**STATE OF NORTH CAROLINA  
UTILITIES COMMISSION  
RALEIGH**

DOCKET NO. E-100, SUB 165

In the Matter of:	)	NC WARN AND CENTER FOR
2020 Biennial Integrated Resource	)	BIOLOGICAL DIVERSITY'S
Plans and Related 2020 REPS	)	INITIAL COMMENTS ON
Compliance Plans	)	DUKE'S INTEGRATED
	)	RESOURCE PLANS

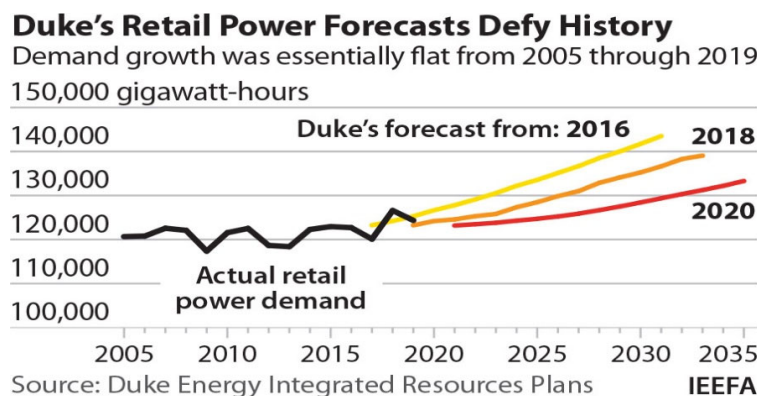
Date	Peak demand (MW)	Unused and available supply assets (MW)	Equivalent ORM (%)
DEC			
01/05/18	19,077	CT = 1,071 MW pumped storage = 547 MW hydro = 241 MW coal = 49 MW steam = 168 MW <u>DSM = 428 MW</u> Total = 2,504 MW	13.1 (no non-firm imports)  18.5 (non-firm imports add 29% to reserve margin)
DEP			
01/05/18	15,048	CT = 857 MW (non F.O.) CC = 103 coal = 24 <u>DSM = 478 MW</u> Total = 1,462 MW	9.7 (no non-firm imports)  13.7 (non-firm imports add 29% to reserve margin)

For all of these reasons, among many others described in Mr. Powers's report (Attachment 1), Duke Energy has ample capacity to reliably meet demand even during extreme winter peak events.

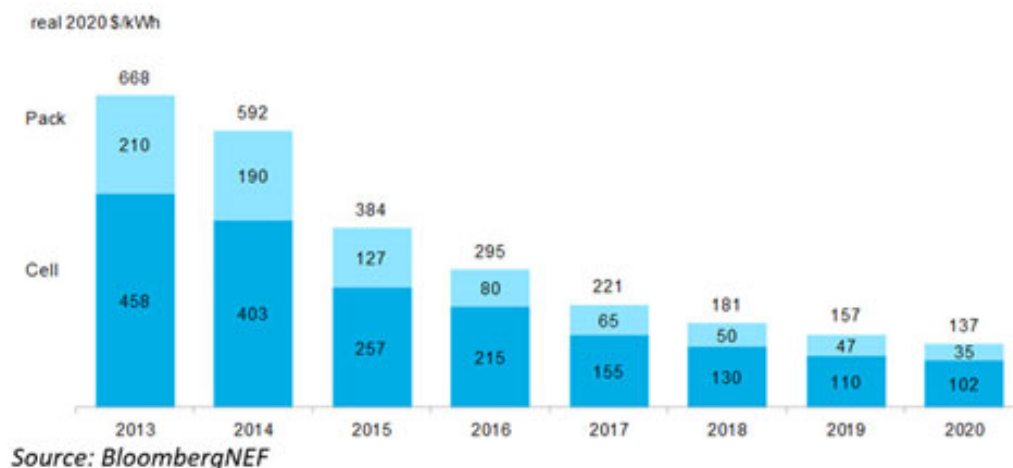
the 2027-2028 timeframe, which are the mid-range years for the 15-year planning horizon.<sup>82</sup>

In fact, a “survey of leading battery manufacturers indicates that battery capital costs are already lower than the NREL forecast for 2027-2028 and steadily declining.”<sup>83</sup> Indeed, battery capital costs are expected to reach approximately \$100/kWh by 2023, which is about one-half the lithium battery price assumption assumed by Duke Energy for 2027-2028.<sup>84</sup> The following figure illustrates the rapidly declining cost of battery storage:<sup>85</sup>

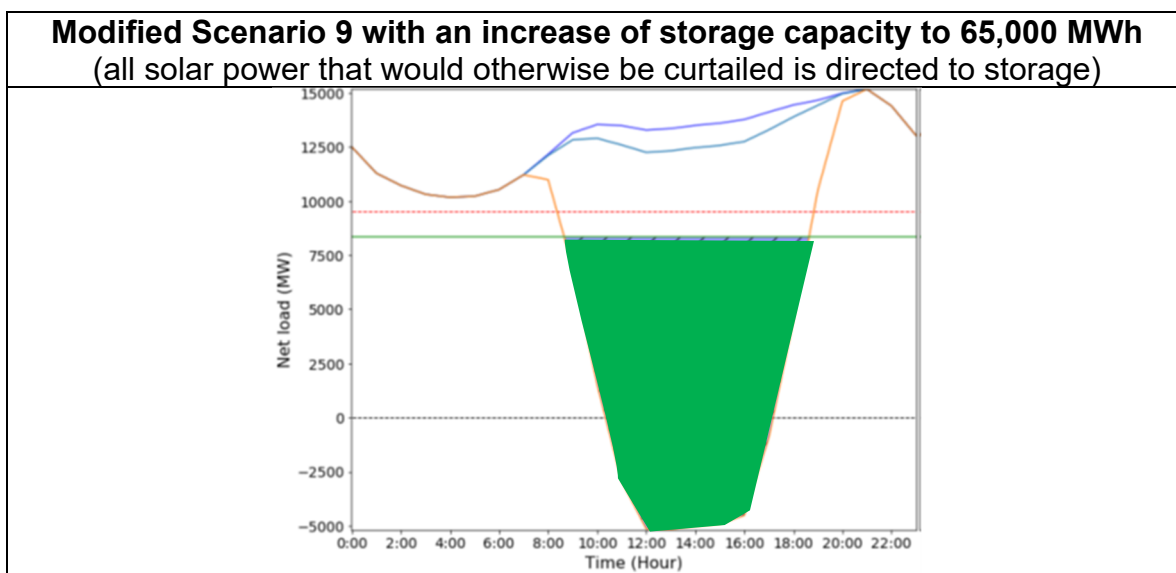
Moreover, completely absent from the NREL study is a scenario which increases battery storage capacity consistent with the amount of solar capacity to eliminate, or nearly eliminate, solar power curtailments during light load spring

and fall days.<sup>97</sup> By way of example, if Scenario 9 were modified to increase the amount of storage to 65,000 MWh, the amount of solar curtailment would be reduced to zero.<sup>98</sup> This is illustrated by the following figure:<sup>99</sup>

“The single solar and storage scenario analyzed by NREL (Scenario 9) leaves the mistaken impression that above some moderate threshold, with or without storage, much of the produced solar power will go to waste (curtailment).”<sup>100</sup> However, this “conclusion” is exclusively the result of artificial limitations placed upon solar paired with battery storage. “When the storage capacity is properly sized to the solar capacity”—as shown in the figure appearing immediately above—“all of the solar capacity can be put to productive use, including on spring and fall days with light demand.”<sup>101</sup> Therefore, when
